T2010A-01

Modification Recommended Service Note

T2010A LTE Wireless Communications Test Set

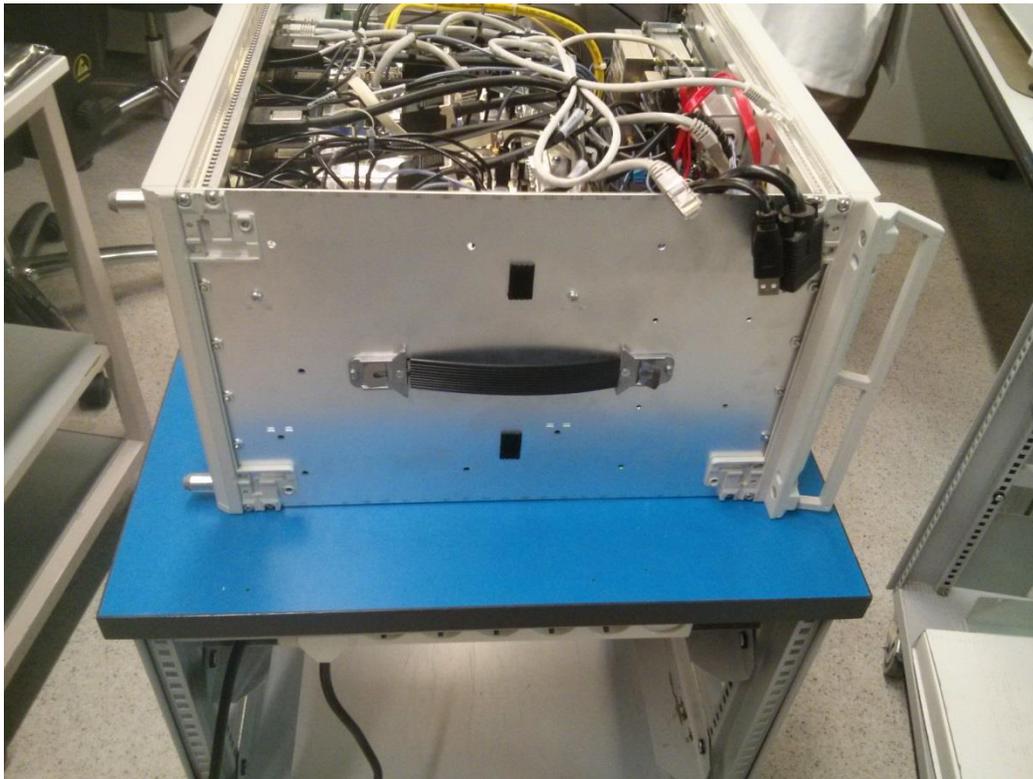
If RAM modules are not well engaged to the PC board memory slots, they are not detected by the PC board, and the instrument does not boot up.

The typical symptom is a black display (no image). Usually, RAM issues are reported by the BIOS system with a specific beep code (three short beeps).

A design change was implemented in the manufacturing process, starting from serial number MY53245001, to prevent this issue to happen.

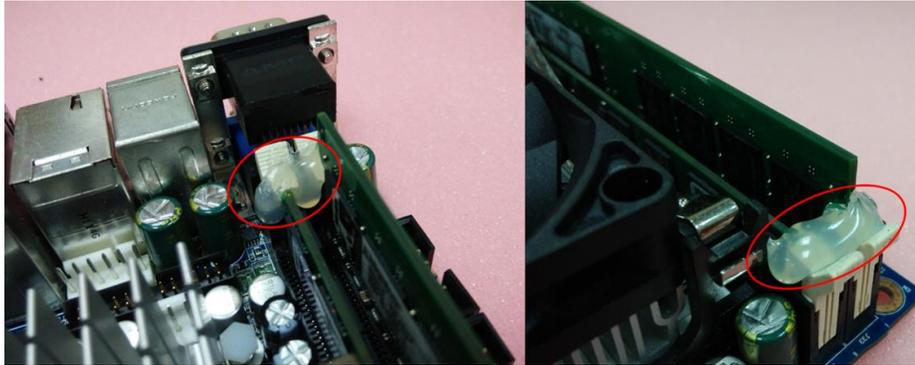
Check that the RAM modules are secured with hot melt glue as shown in the following pictures:

The glue must be applied all the way down from the locker to the memory slot, and both RAM modules must be tied together (i.e. building a “bridge” between the latches).

- I. If the RAM modules are correctly glued, NO action is required.
- II. If no glue is present, apply the holt melt glue.
- III. If a different glue (yellow colour) had been used, remove the existing glue, and apply the holt melt glue.
- IV. If it had not been applied correctly, remove the existing glue, and apply the holt melt glue properly.
